M-03 Updates for Cut-In Process

Operating Committee
October 5, 2023

4.2.3 Energizing New Facilities

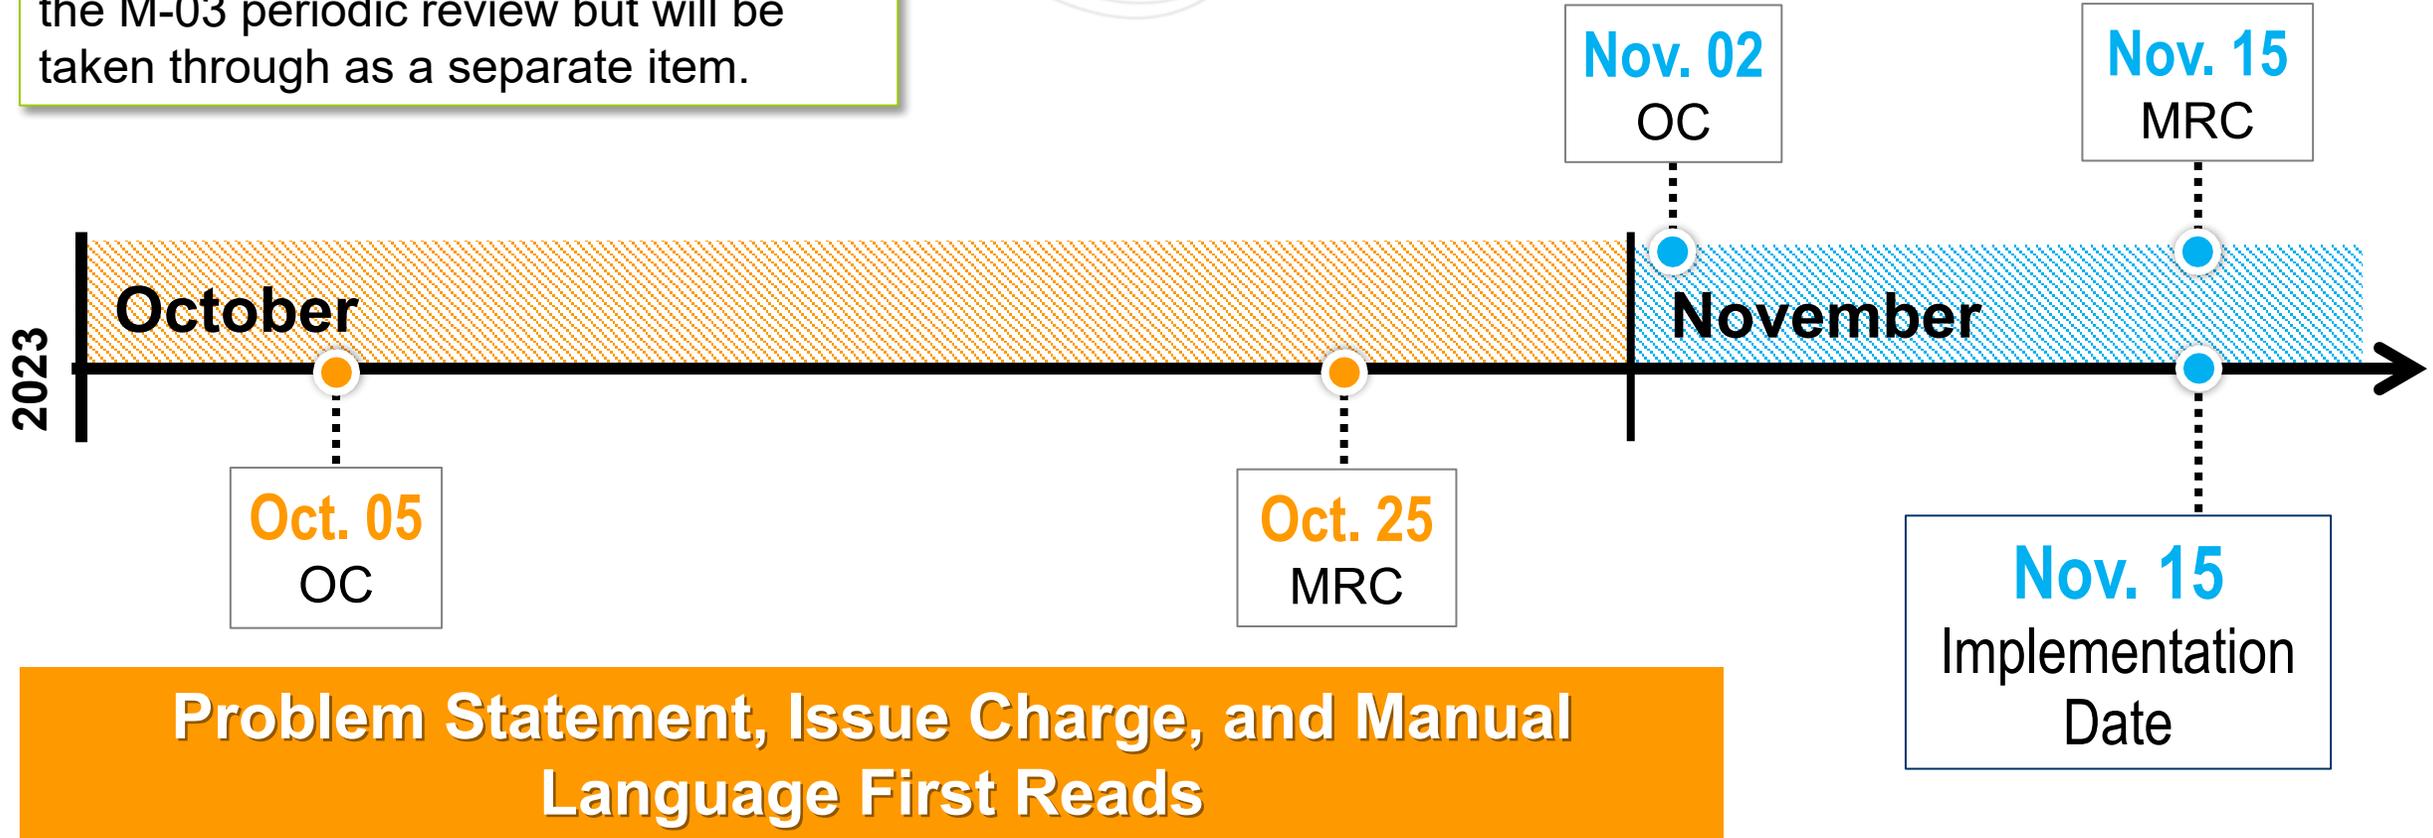
In order for PJM to properly model changes in system configuration, as much advanced notification as possible is required when a new facility, a reconfigured facility, is scheduled to be energized. This also includes a re-conductoring or equipment replacement that changes the impedance or rating of a facility. Transmission Owners must notify PJM of such changes by checking the Cut-In flag in the eDART outage ticket. This information should be submitted to PJM as far in advance as possible to ensure inclusion in the quarterly EMS model update but at minimum shall be consistent with the outage submittal rules. If energizing a new facility involves multiple outages in different periods, the Cut-In flag shall only be checked for the outage that upon completion will result in the energized facility. Once the ticket marked 'cut-in' is ready to energize, in order to maintain reliability and monitor the system accurately per NERC standards FAC-008 and FAC-011, PJM must have all parameters critical to the cut-in process (i.e. ratings, impedance etc.) in place. For this reason, new data must be submitted and implemented or existing parameters must be verified by 11:00 the day before scheduled energization. If this is not done, then PJM will extend the scheduled end time of the cut-in ticket by one business day as long as extending the outage is not expected to cause reliability concerns.
